V-24-05	Staff Report – May 16, 2024										
Application Type:	Area Variance										
Summary of Proposed Action:	Applicants are seeking relief, in regarding to the standards of MX-4 Zone District, to establish a “projecting sign” on the west elevation of a multi-unit dwelling apartment, named “The CODA”. The proposed sign will exceed maximum sign area, maximum sign face height, maximum projecting distance from building façade, and to be located above the third floor.										
Project Address:	301 South Crouse Avenue & East Genesee Street (Tax Map ID: 048.-05-04.3)										
Owner/Applicant	TLSP CODA LLC (Owner) James Trasher, CHA Consulting Inc. (Applicant)										
Zoning Violations	<p>The proposed project is seeking an area variance from the Board of Zoning Appeals to violate the following Zoning Ordinances:</p> <ol style="list-style-type: none"> ReZone, Art. 4, Sec. 4.8H(2), Sign regulations for MX-4 Zone District: Maximum sign area for Projecting Sign is 10 SF. ReZone, Art. 4, Sec. 4.8H(2), Sign regulations for MX-4 Zone District: Maximum sign face height for Projecting Sign is 4 FT. ReZone, Art. 4, Sec. 4.8H(3)k., Sign regulations for Projecting Signs: Projecting signs sh

1 WEST ELEVATION (SOUTH CROUSE AVENUE)
A.02 SCALE: 1/16" = 1' - 0"

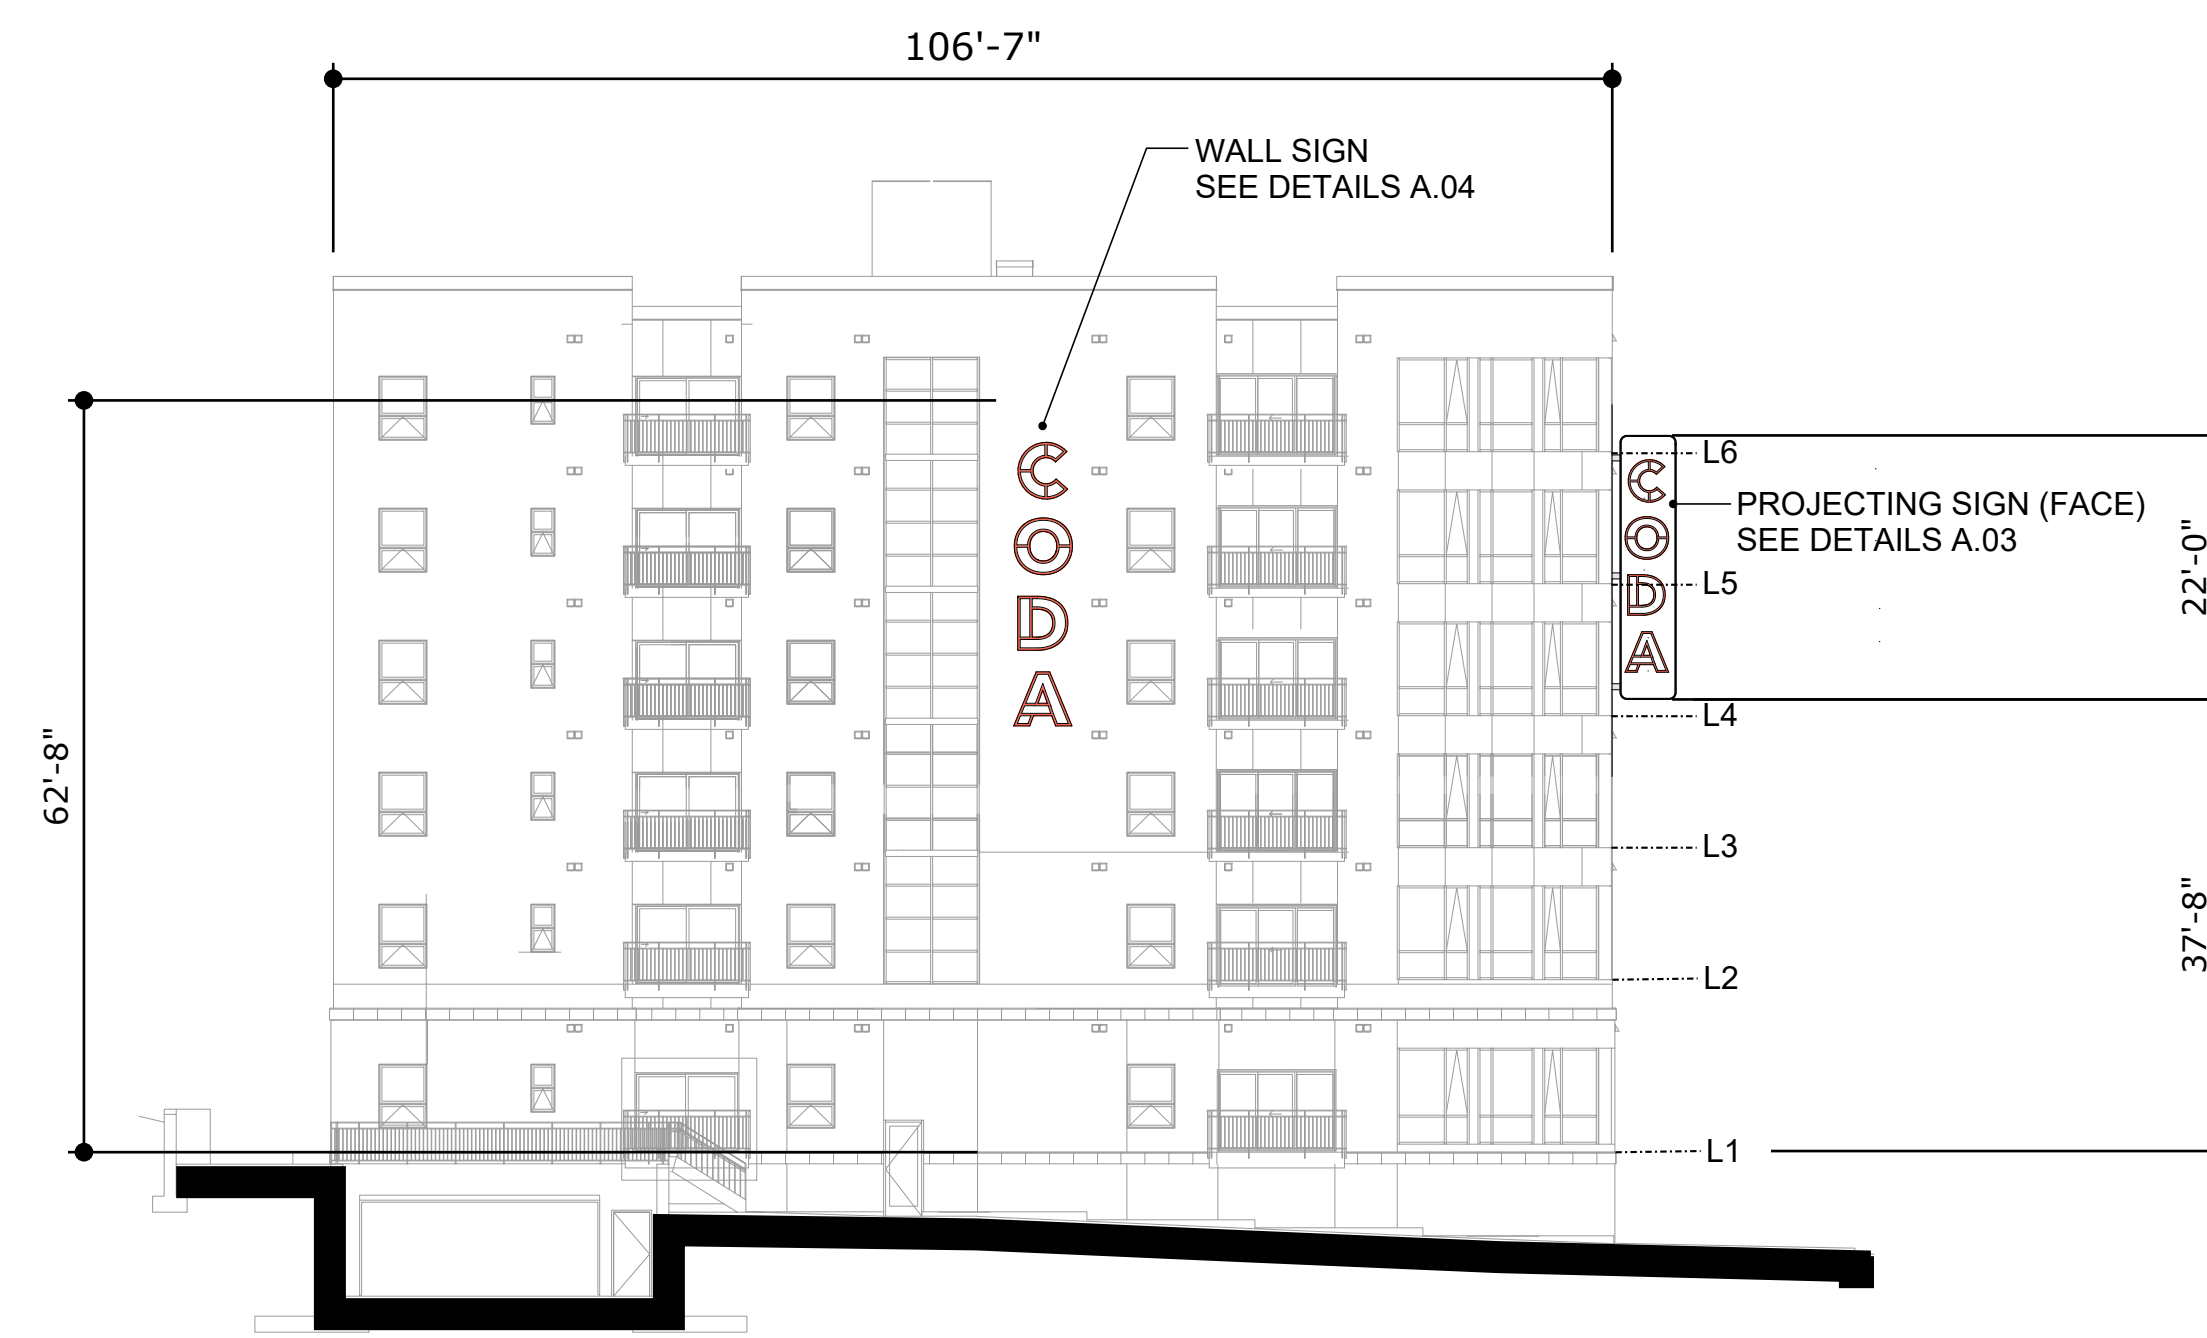
The Board generally discourages allowances for such substantial signage variances, which can dominate the façade of the building and detract from desired community character.

Approval	Status	Status Date	Reviewer	Comments
Board of Zoning Appeals	Pending	03/18/2024		
Zoning Planner	On Hold	04/18/2024	Zhitong Wu	On hold for approval from BZA.
Landmark Preservation Board	Internal Review Complete	05/10/2024	Kate Auwaerter	The SLPB reviewed the application materials at its 5/9/24 meeting. The SLPB determined that the projecting sign facing S. Crouse Ave ("Sign 2") would have no impact on historic resources.
